UNITED STATES PATENT AND TRADEMARK OFFICE

APPLICATION NO.	FILING DATE	FIRST NAMED INVENTOR	ATTORNEY DOCKET NO.	CONFIRMATION NO.
10/696,984	10/30/2003	James D. Dale	1062/D74	7856
2101	7590	09/23/2005	EXAMINER	
BROMBERG & SUNSTEIN LLP 125 SUMMER STREET BOSTON, MA 02110-1618			LUGO, CARLOS	
			ART UNIT	PAPER NUMBER
			3676

Office Action Summary

DETAILED ACTION

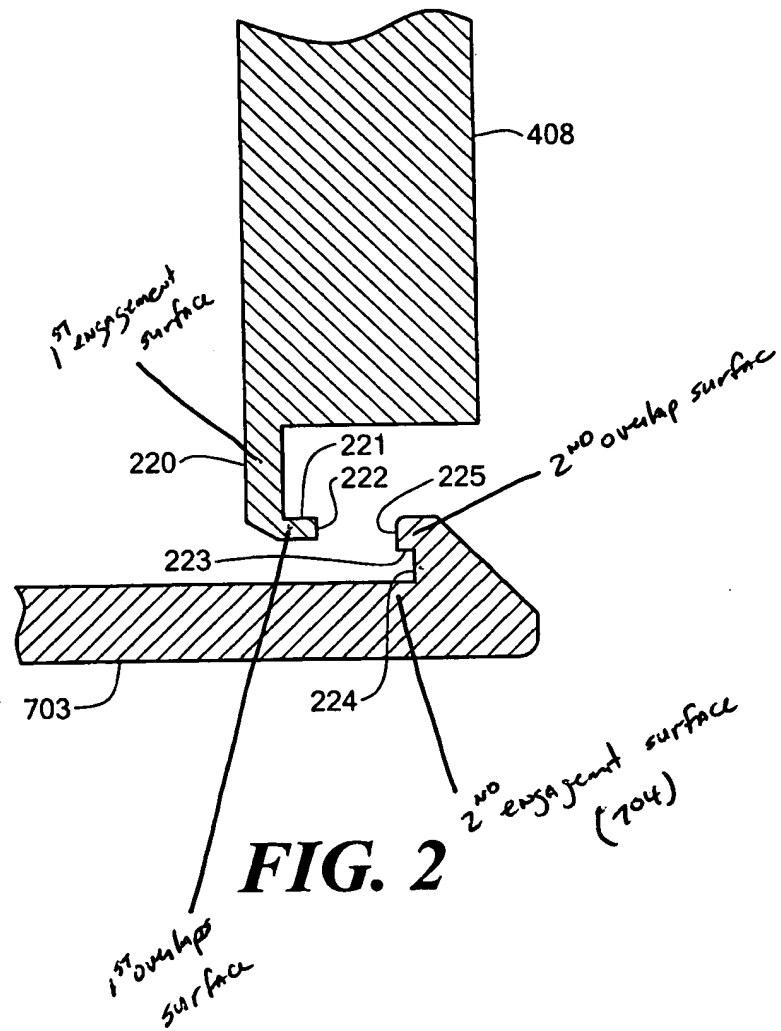
Further, claims 1 and 34 recite that the first engagement surface at least partially contacts the second engagement surface and the first overlap surface at least partially overlaps the second overlap surface. It is unclear how the first engagement surface 220 contacts the second engagement surface 740. As seen in Figure 2 (see attachment #1), the first engagement surface 220 never has contact with the second

engagement surface 704. The surface that contacts the second engagement surface is the first overlap surface 221. Therefore, until proper correction and/or clear explanation by the applicant, the limitation will be examined as the assembly having a first engagement configuration that contact a second engagement configuration at the door.

Attachment # 2

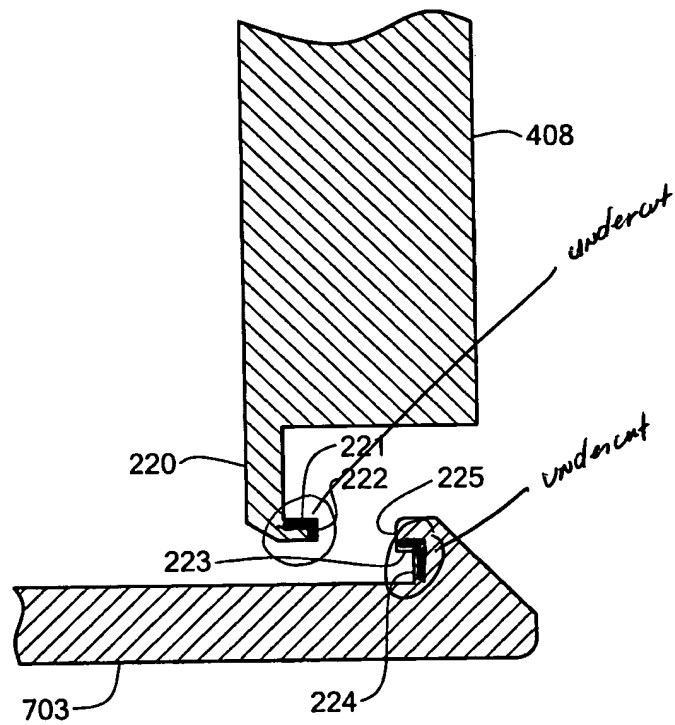
Claims 3,22 and 35 recite that the second engagement surface forms a projection for engaging the undercut. It is unclear what the applicant is trying to claim as his invention since, as seen in attachment #2 and as described in Page 8 Lines 2-4, the second engagement surface, at 703, also forms an undercut that engages the undercut of the first engagement surface 220. Therefore, in order to continue with the examination, the limitation will be examined as having a second undercut for engaging the undercut of the first engagement surface. Appropriate correction is required.
